SUNDRY NOTICES AND REPORTS ON WELLS REPO

ell. Use Form 3160 - 3		posals.		
SUBMIT IN TRIPLICATE- Other instructions on reverse side.				7 If Unit or CA/Agreement, Name and/or No 8 Well Name and No.	
. Type of Well Oil Well □ □					
Name of Operator CHI OPERA	TING, INC.			Munchkin Federal, #21 9 API Well No.	
a Address P.O. Box 1799, Midland, Texas	79702	3b Phone No (include area code) 432-685-5001		30-015-37987 10 Field and Pool, or Exploratory Area	
Location of Well (Footage, Sec.,	1)		Benson Delaware		
900' FNL & 1100' FWL SEC. 12-T19S-R30E				11 County or Parish, State	
!				EDDY

PECOS DISTRICT CONDITIONS OF APPROVAL

WELL NAME & NO.: | Munchkin Federal #21 SURFACE HOLE FOOTAGE: | 900' FNL & 1100' FWL

Figure 3-1A

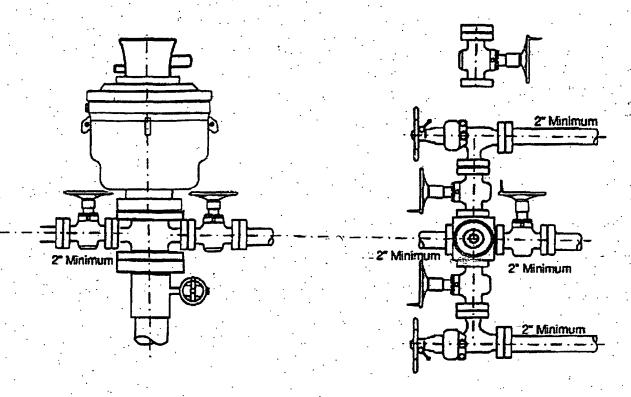
CHI Operating, Inc. is preparing to drill the above captioned well and the drilling superintendant has requested that the BOP be changed from a 3M system to a 2M system. A copy of the BOP is attached.

- 2. Minimum working pressure of the blowout preventer (BOP) and related equipment (BOPE) required for drilling below the surface casing shoe shall be **2000 (2M)** psi.
